Minutes of Meeting

Doc.-No.: HP-2-ASPI-MN-1346

Subject: SPIRE IID-B Convergence Mtg.

Herschel SPIRE IID-B updates

Figure 4.1 Spire in Herschel.

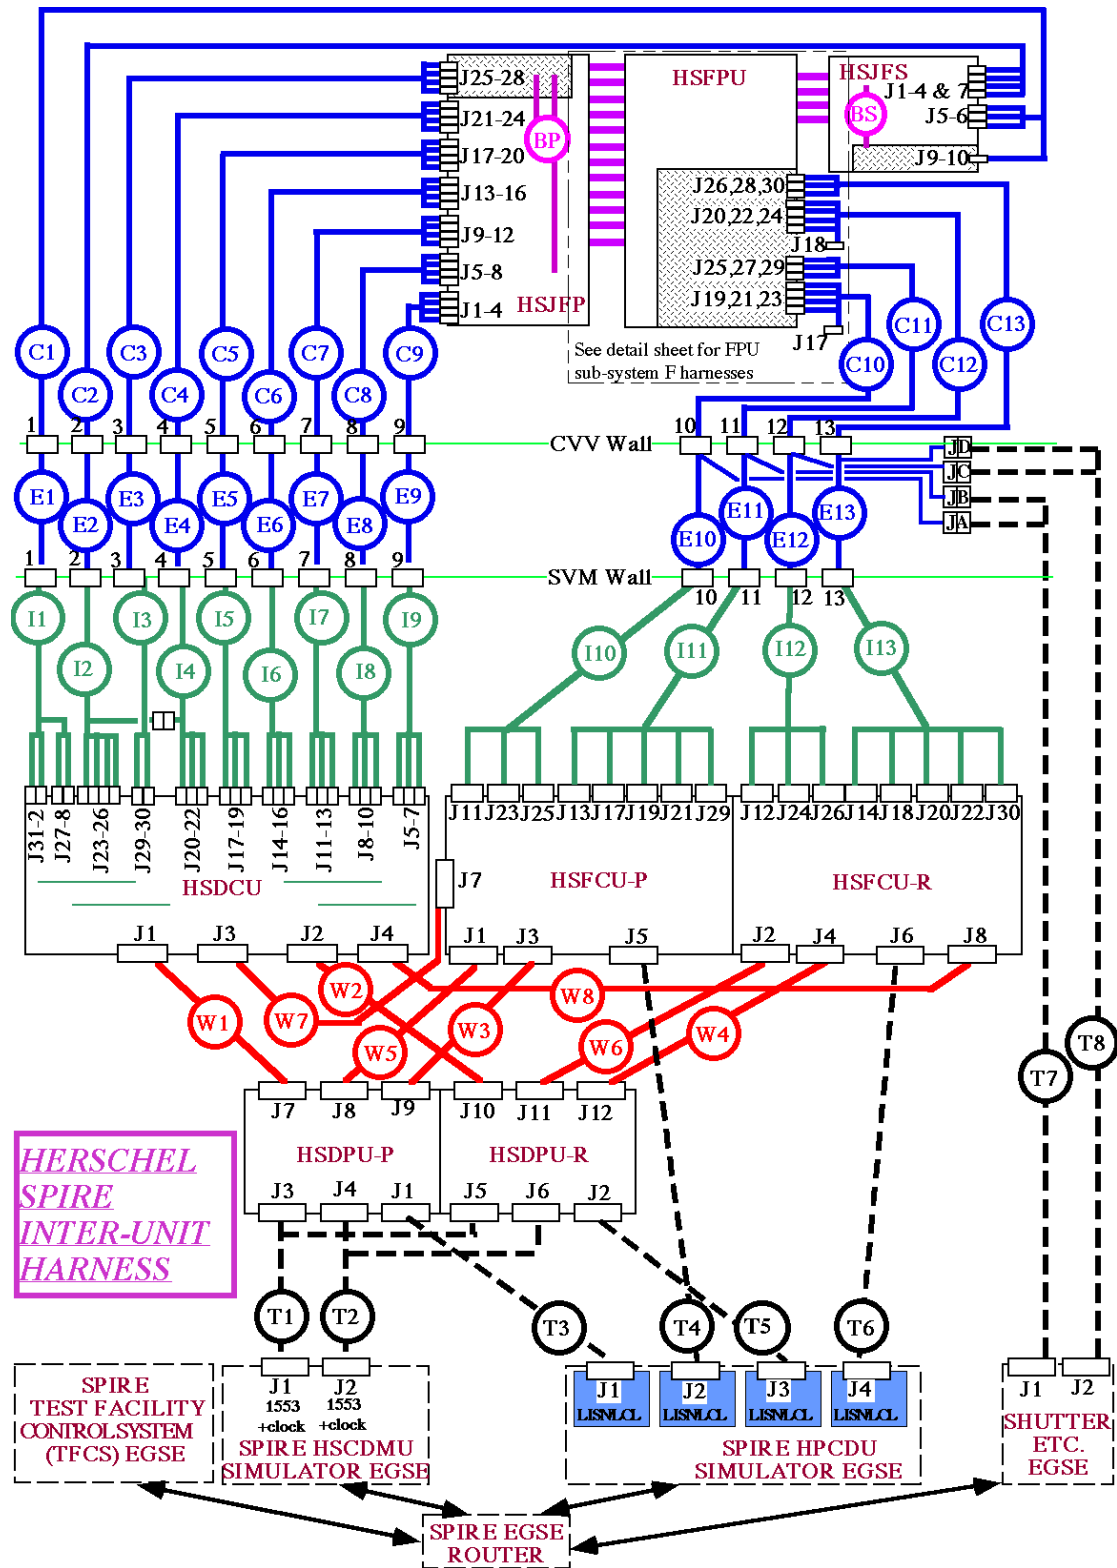
4.1	Insert figure 4.1 that follows to give overall view				
4.4	Bring into line with section 5.1				
4.6 and 4.7	Add "for latest information, refer to RD6."

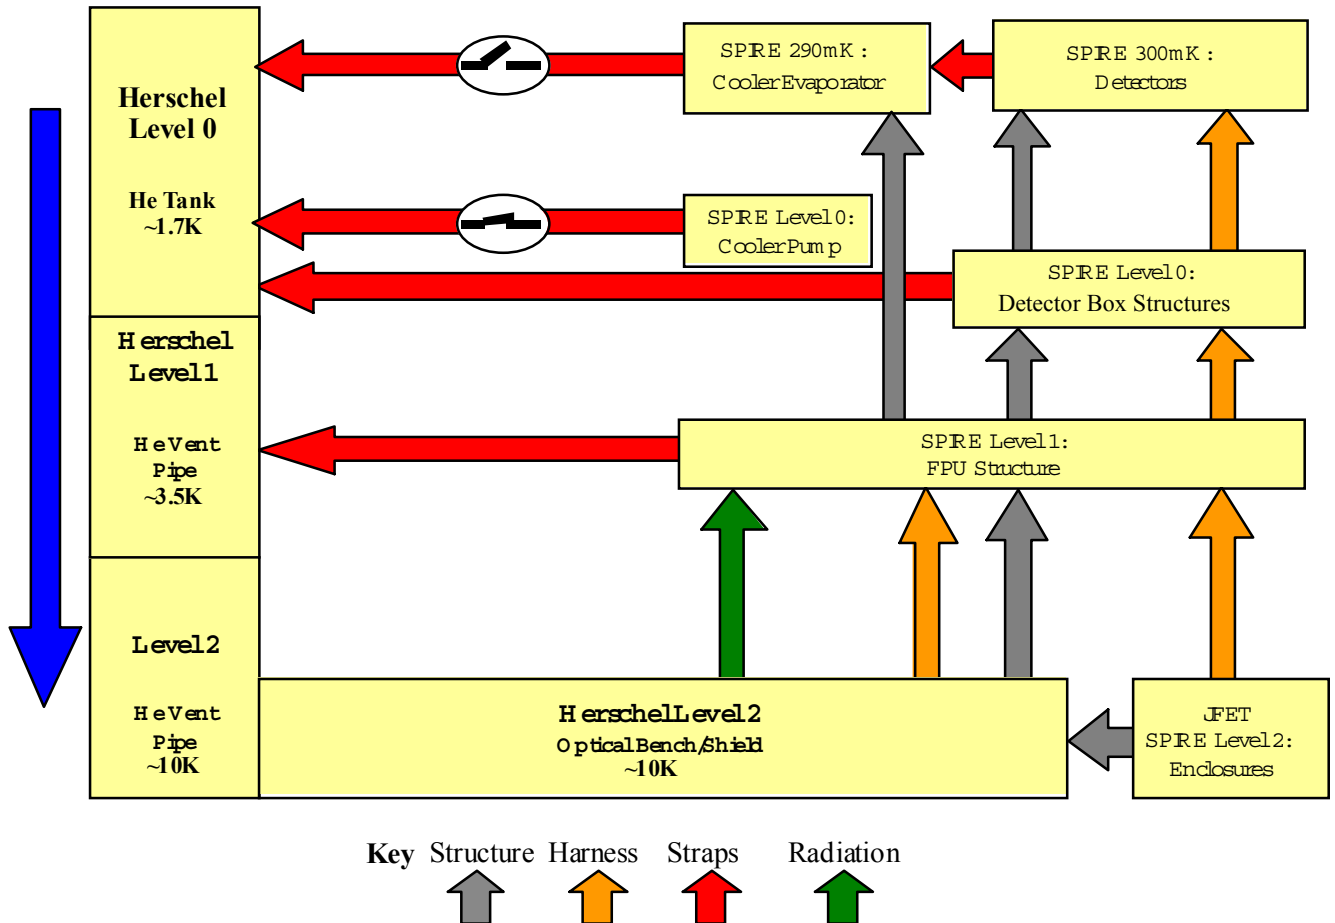
The following paragraphs (5.7.1 to 5.7.1.2) are a statement of the SPIRE requirements on the Herschel system. However, industry can not commit to the requirements below, but is investigating refining its design with these as objectives. A number of technical options have been identified, both on satellite and SPIRE instrument sides, which need to be analysed to converge to an interface definition. An objective is to meet both the cryostat lifetime and SPIRE thermal requirements. This shall be settled and formalized via the regular Change Request process.

* Continuous temperature limit.

** Short-duration temperature limit for bake-out during a maximum of 72 hours.

*** Certain sub-systems may not be able to be operated above 20 K.

**** For sorption cooler recycling see 5.7.1.1

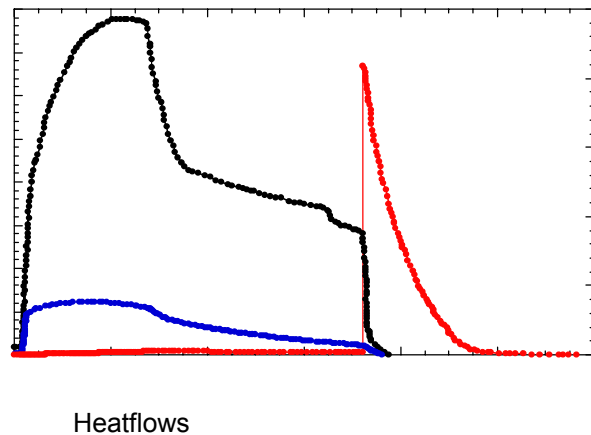
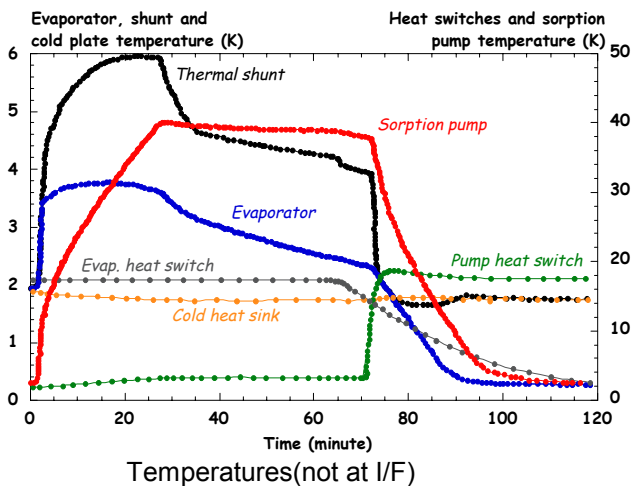
First the sorption pump is heated to ~40K and the evaporator's heatswitch ON to conduct heat to the HPLM Helium II tank, so the ³He condenses back into the cooler's evaporator. A temperature of the evaporator during this phase maximises the recycling efficiency (i.e. ratio of Liquid ³He to condensed ³He), a factor in maximising its subsequent 300mK hold time. The sorption cooler manufacturer stipulates a conductance of >0.1Watts/Kelvin between the HPLM Helium II tank and the sorption cooler evaporator heatswitch I/F.

At the end of the condensation phase of the cooler's regeneration, the heat switch on the sorption pump is turned ON and the switch on the evaporator is turned OFF. There is a substantial (~450mW) peak power from the sorption pump to the cryostat as it is re-cooled. The design of HPLM Helium II cryostat should be such that this peak power and associated energy does not have any significant impact, such as cryogen surface film breakage. During this phase, the evaporator strap shall be below 2K, to avoid re-evaporating the condensed ³He.

These operating modes mean that the Pump Strap and the Evaporator straps must be sufficiently insulated from each other. There are thus two straps from the cooler, one for the sorption pump and one for the evaporator. In this way, during normal operation, the temperature of the evaporator strap will remain at $T_{bath} + \Delta T$ (as small as possible), leading to a good condensation efficiency and less ³He lost during the cooldown from 1.7 K to 0.3K.
